SUBJECT: SOUTH TEXAS PROJECT, UNITS 1 AND 2 - AMENDMENT NOS. 104
AND 91 TO FACILITY OPERATING LICENSE NOS. NPF-76 AND NPF-80
(TAC NOS. MA2296 AND MA2297)

ATTACHMENT TO LICENSE AMENDMENT NOS. 104 AND 91

SAFETY EVALUATION BY THE OFFICE OF NUCLEAR REACTOR REGULATION

SOUTH TEXAS PROJECT, UNITS 1 AND 2

Figure 5.6-6

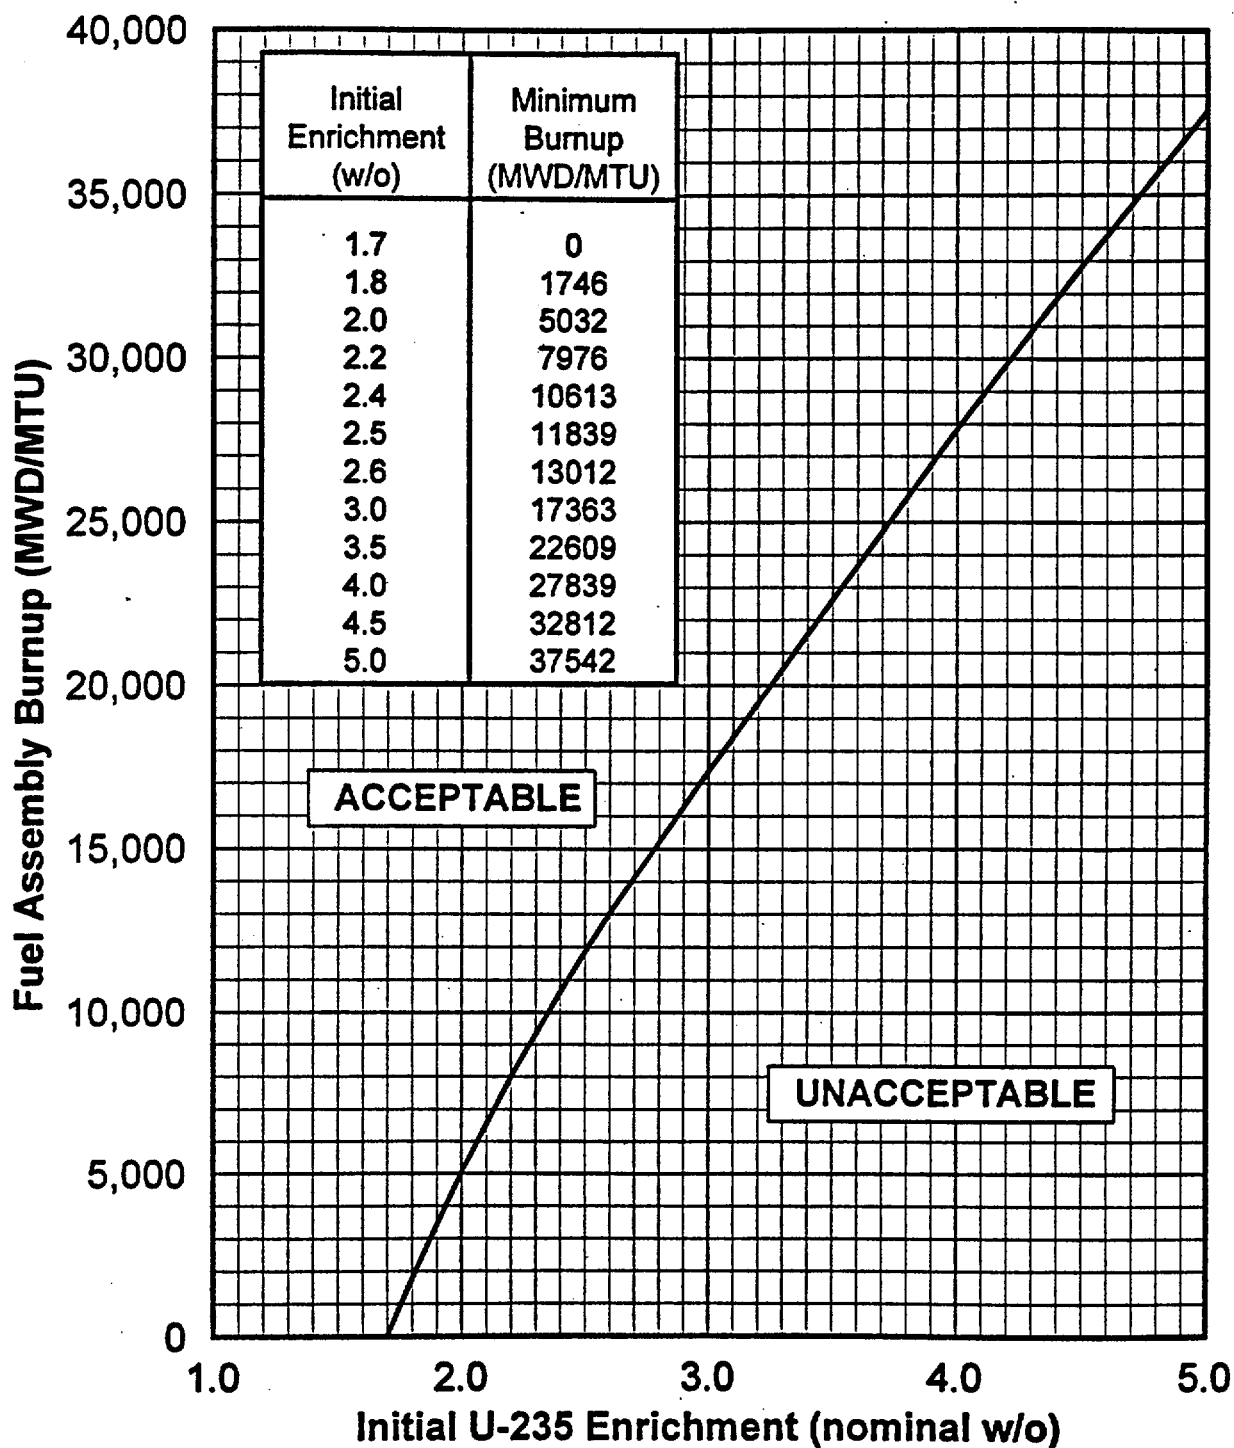
U-235 (Category 5) can occupy any 2x2 matrix with the fourth cell vacant. Higher enriched assemblies must meet the burnup requirements given in TS Figure 5.6-6. The soluble boron concentration that results in $k_{eff} \leq 0.95$ was calculated to be 550 ppm.

- 1) an initial nominal enrichment of less than or equal to 1.70 w/o; or
- 2) a minimum burnup as shown on Figure 5.6-6.
